Agenda Item	6.2
Report No	PLS-61-22

HIGHLAND COUNCIL

Committee: South Planning Applications Committee
Date: 18 August 2022
Report Title: 21/02839/FUL: Mr S Entwistle
Land 45M East of Na Sealgairean, Glenfinnan.
Report By: Area Planning Manager – South

Description: Erection of a House.
Ward: 11 – Caol and Mallaig

Tree Protection Plan. Rev B

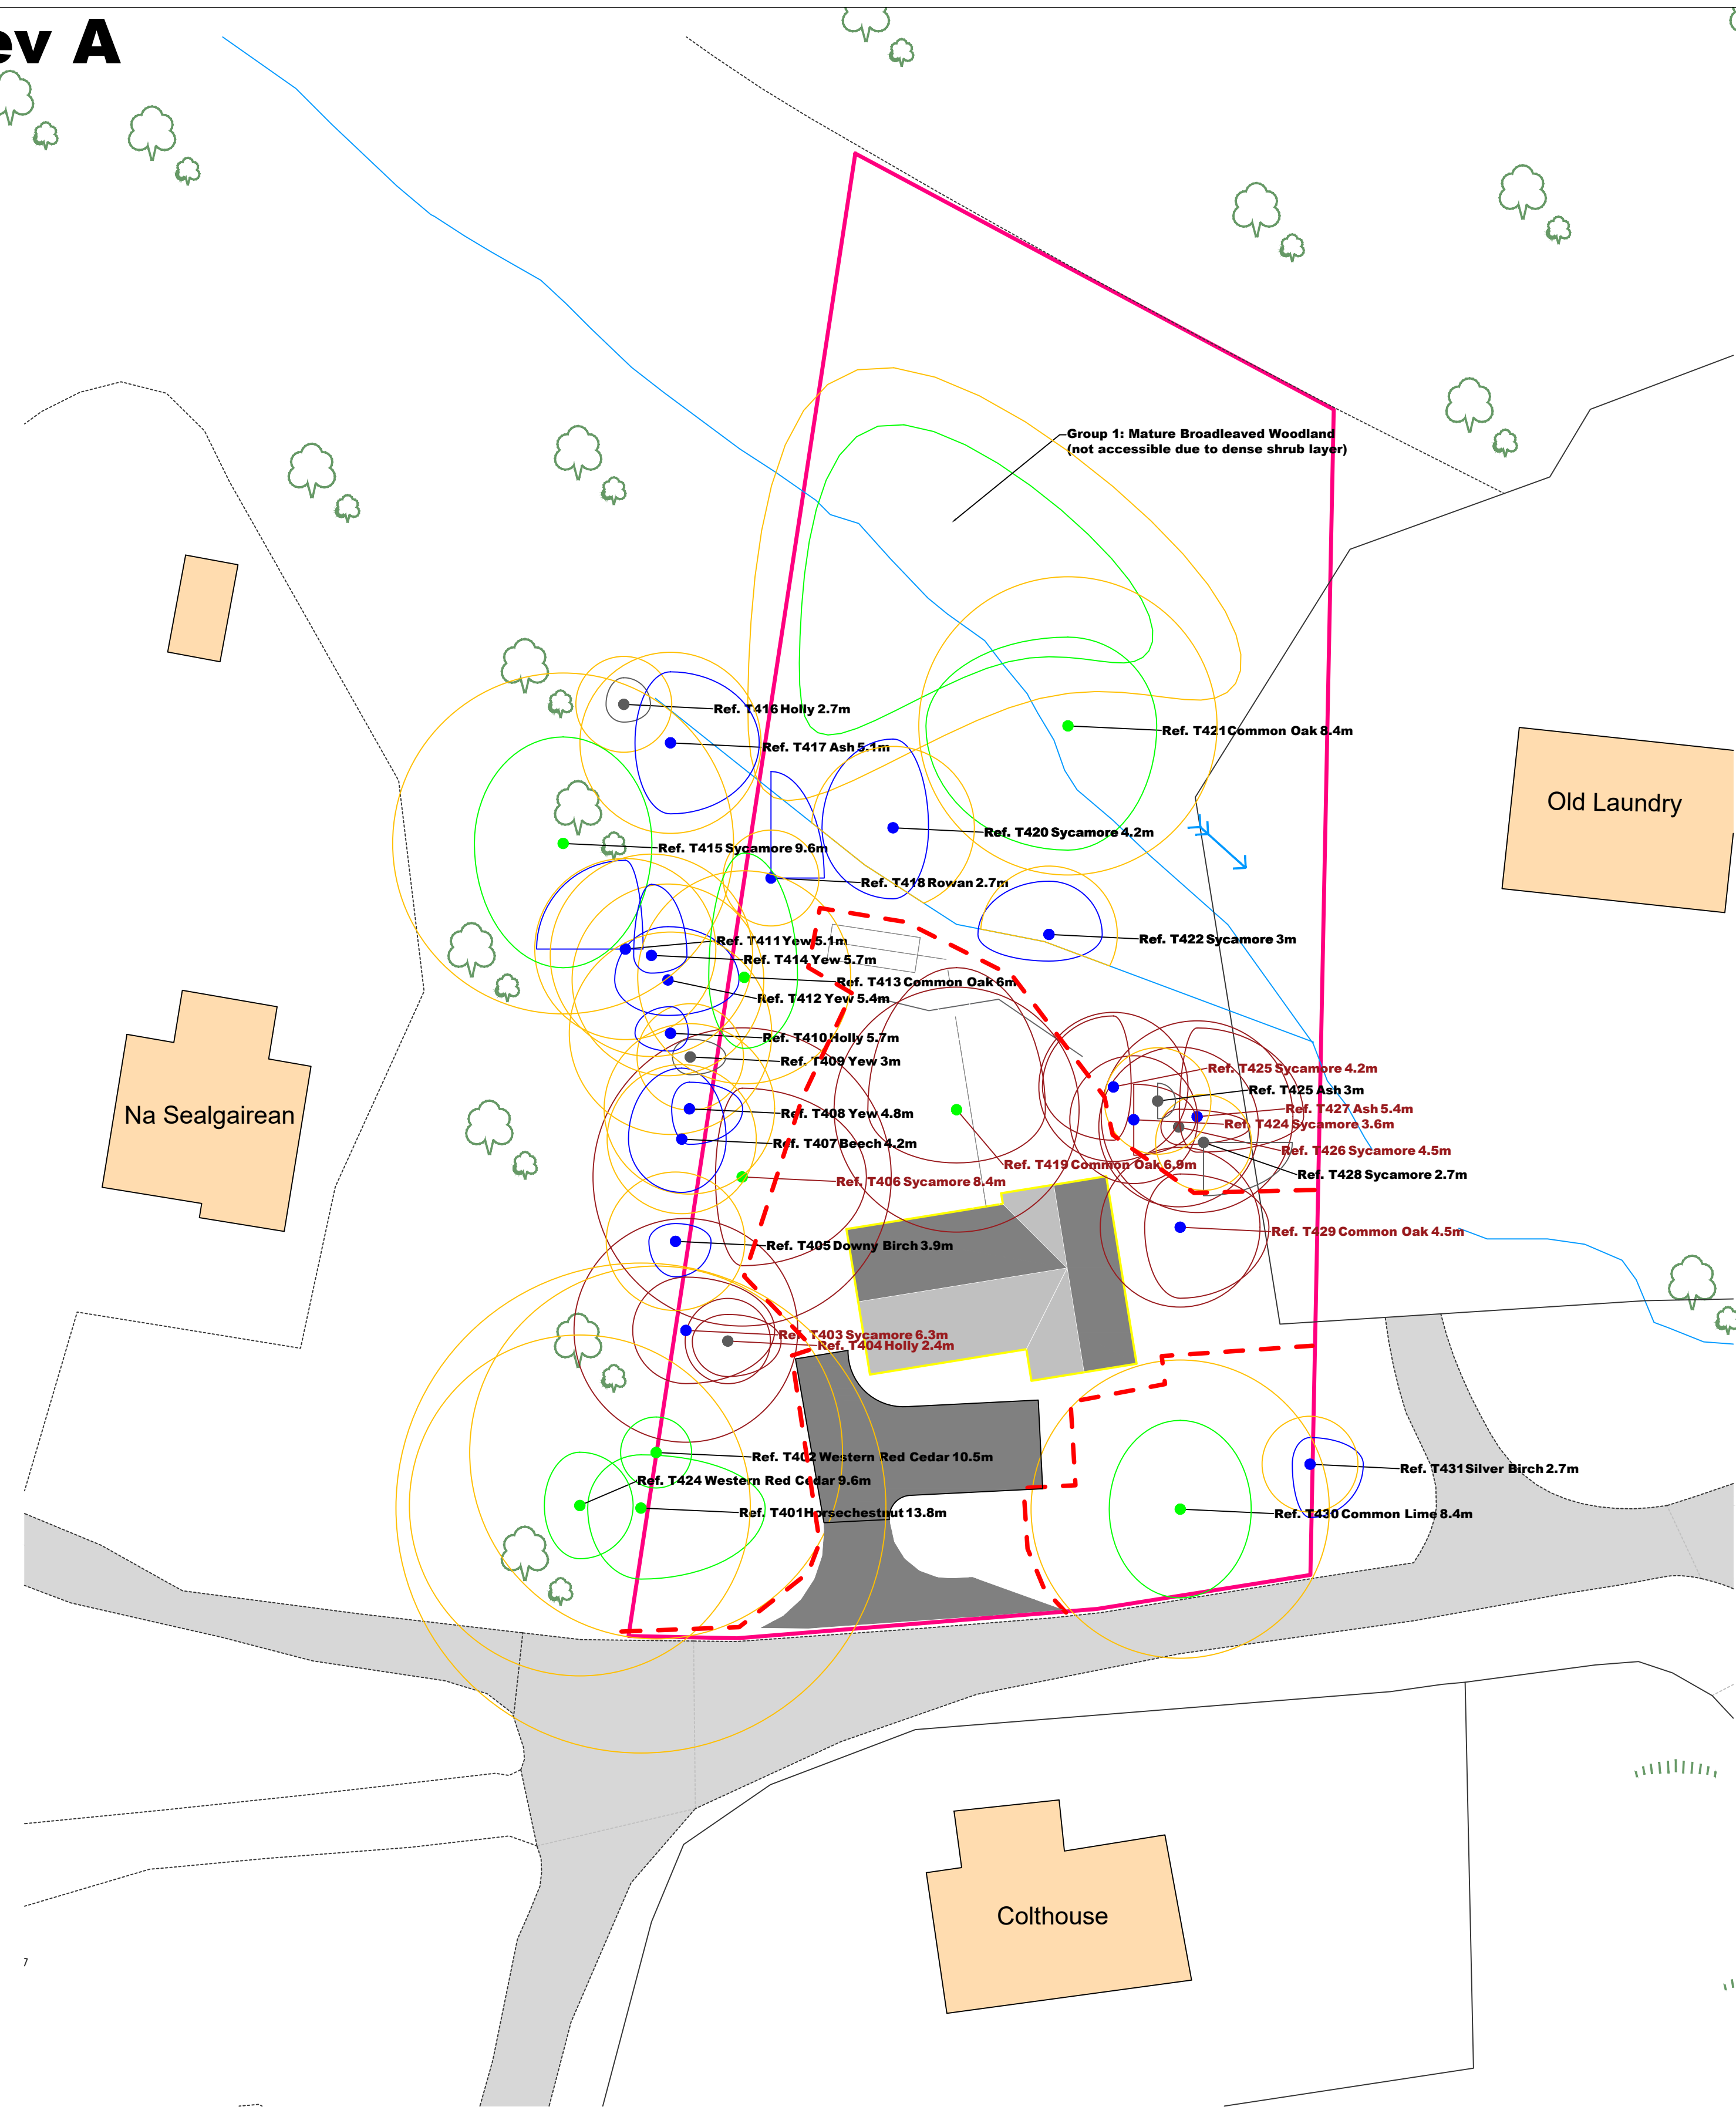
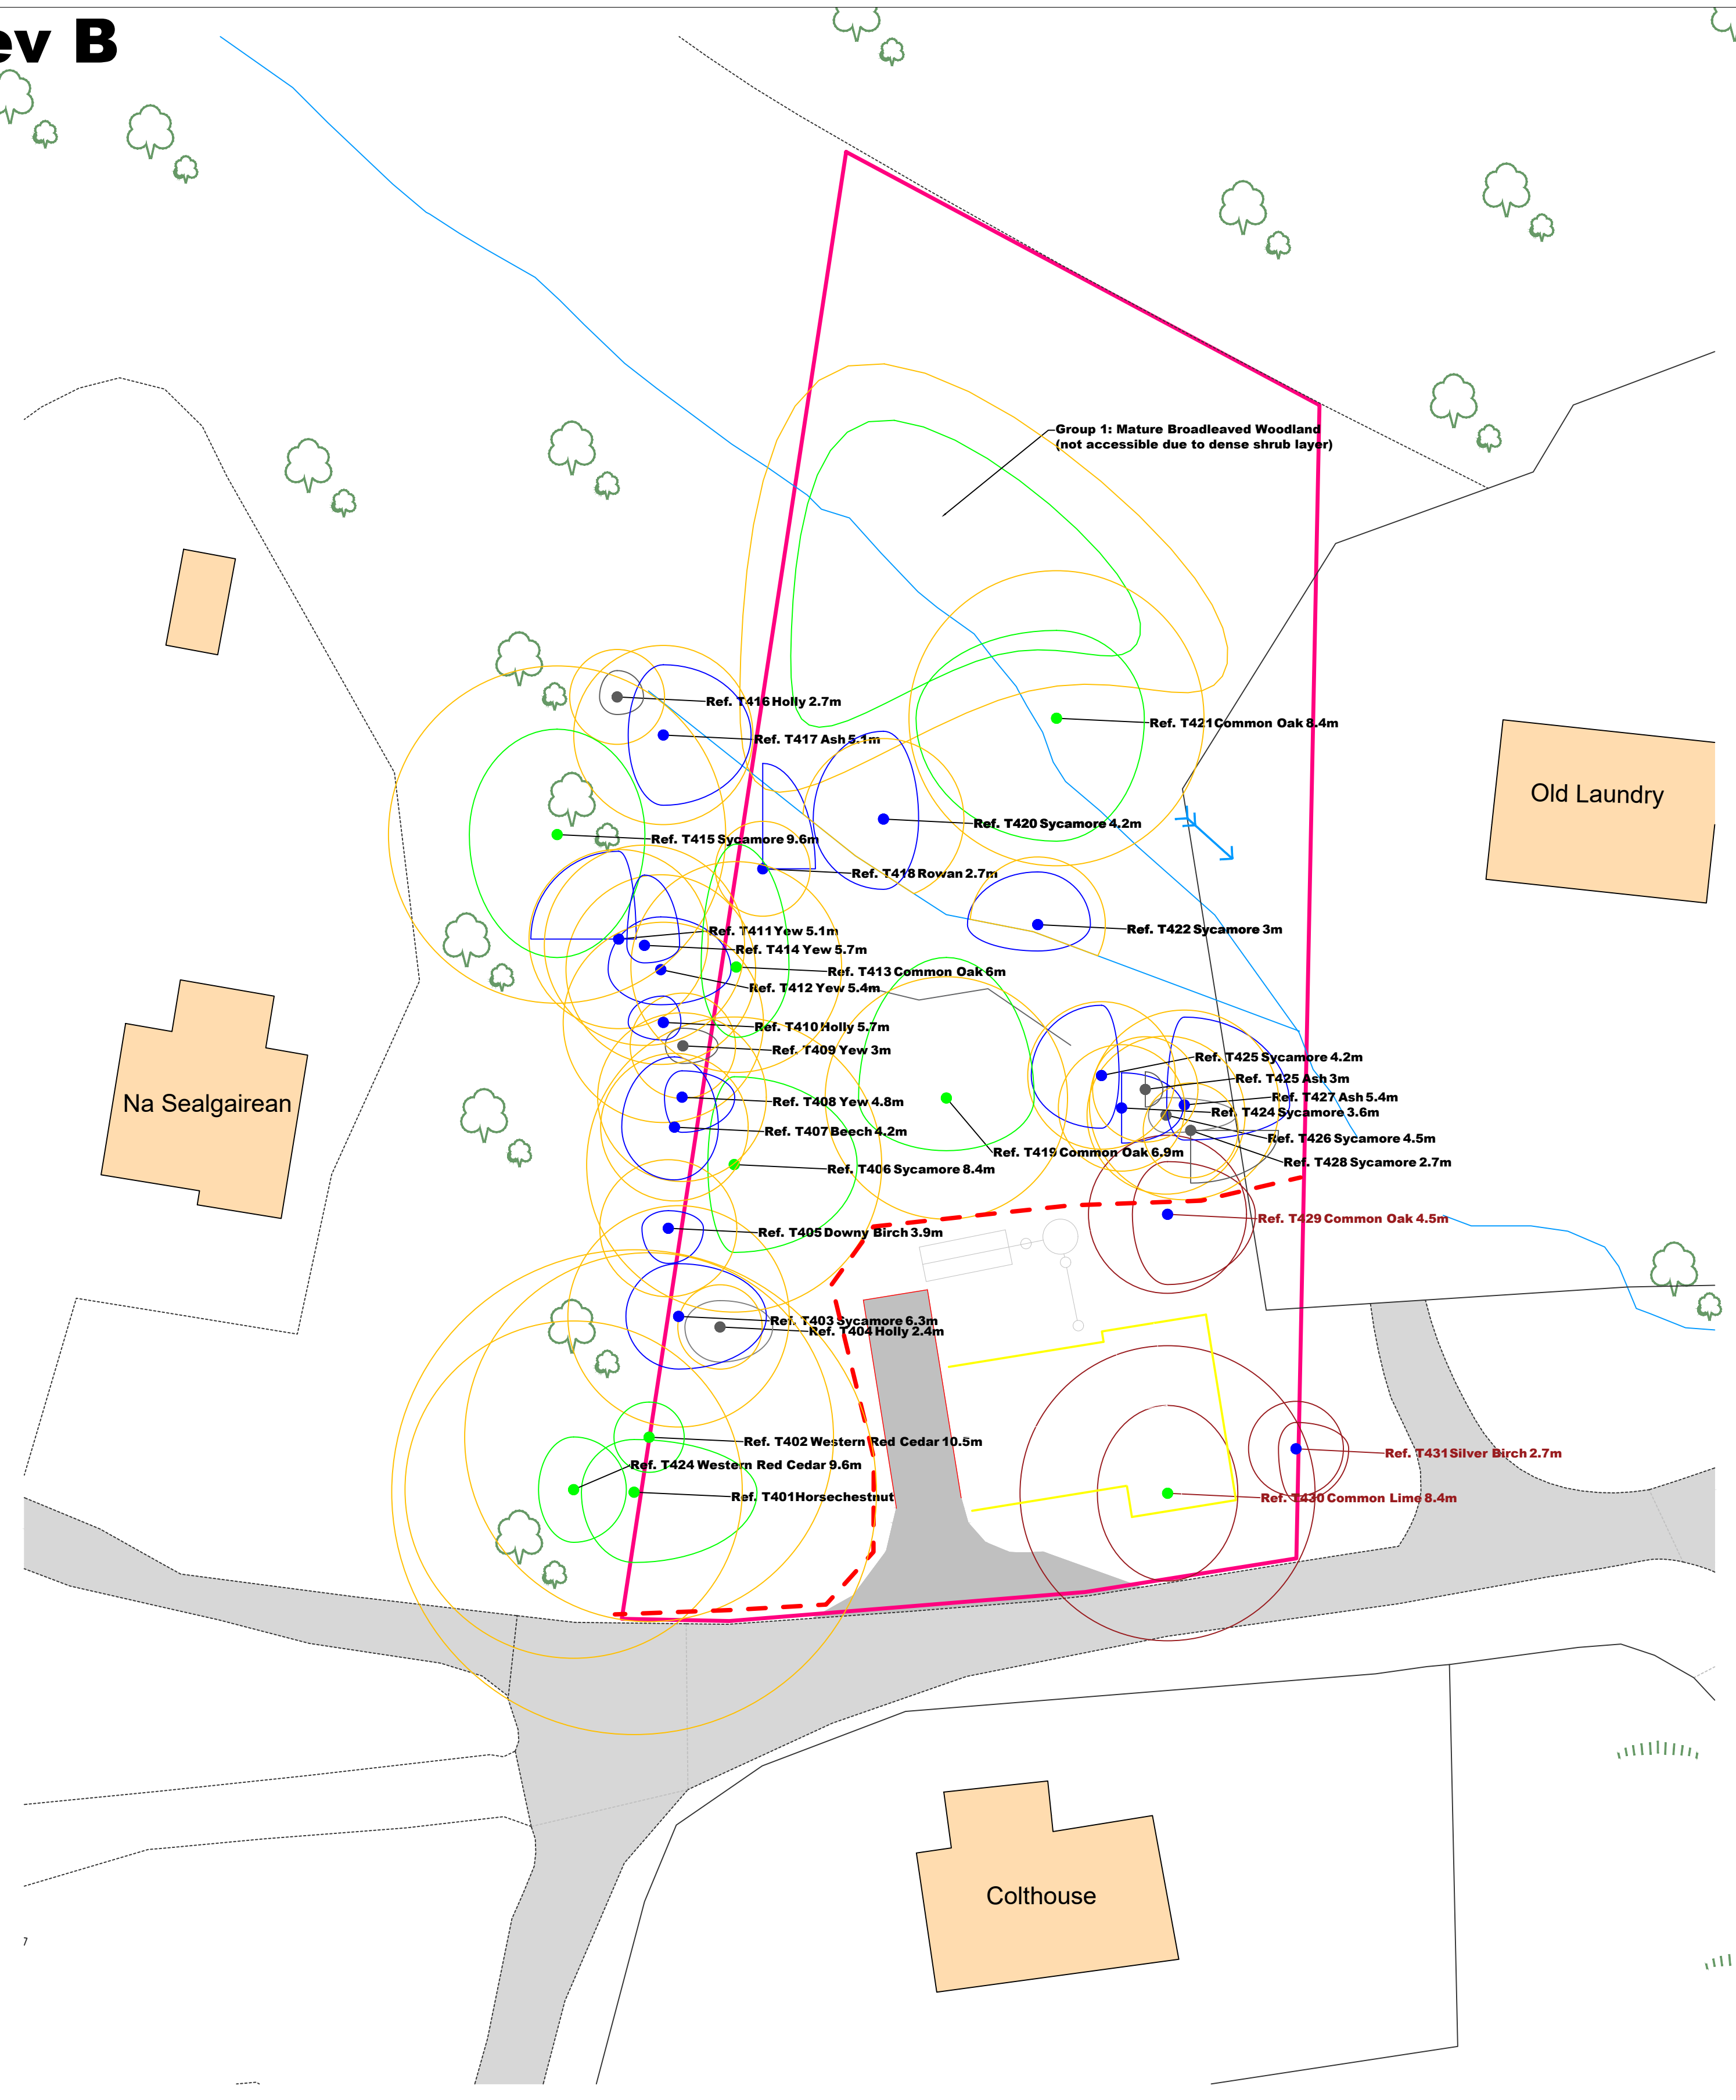
5.1 **Forestry Officer** objects on the basis that the Arboriculture Impact Assessment (AIA) makes no reference to the trees which have already been removed and in addition proposes the removal of a further 9 trees. The Tree Protection Plan (TPP) shows the area of woodland that would be permanently lost within the red dashed line, but all of the land within the plot would be lost to woodland if it were to become garden ground.

- 8.12 The applicant has submitted an Arboricultural Impact Assessment along with a Tree Protection Plan to support this application. The report concluded that a total of nine trees would need to be removed to service the proposed development. Two trees were graded Category A as being 'high value' and five trees being of 'moderate value' (Category B) and a further two trees classed as Category C.

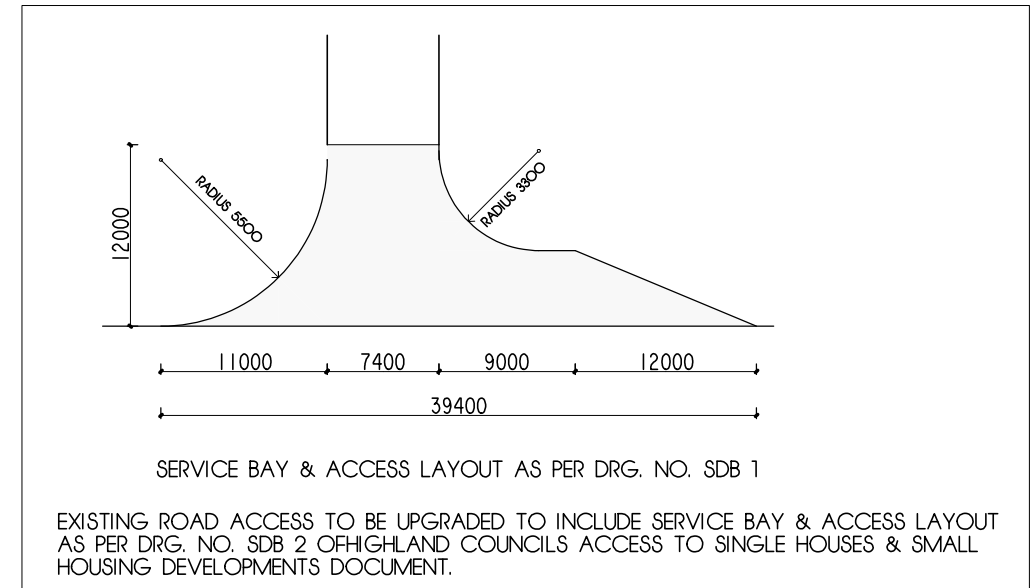
- 1.3 The new information included a new site layout plan and supporting statement.
- 1.4 The most recent site layout plan shows an amended house position in an area set further back from the public road.

- 2.1 While the position of the proposed house indicated within the revised site layout is more in-keeping with the existing settlement pattern, being closer to the alignment of neighbouring houses, the proposed house would continue to adversely impact the area of ancient woodland. Furthermore, the positioning of the proposed house does not leave adequate separation distance from established trees. The assertion that the revised plan will infer no further tree loss is not accepted since the footprint of the house overlaps with the root protection area of an identified Category A oak tree. Further, informal, discussion with the Council's Forestry Team has confirmed this. The proposal does not overcome the first reason for refusal indicated within the original recommendation.

- 2.2 No corresponding details have been submitted of a revised house design to match the revised site plan, therefore only the principle of this revised location has been considered at this stage. The revised site layout plan proposes parking to the west side of the house. However, there is no opportunity for in-curtilage turning. This is contrary to the Council's Supplementary Guidance on Access to Single Houses and Small Housing Developments. The drainage arrangements shown the revised site plan are unlikely to comply with building regulations. As a result, achieving compliant drainage arrangements is likely to further encroach into the woodland
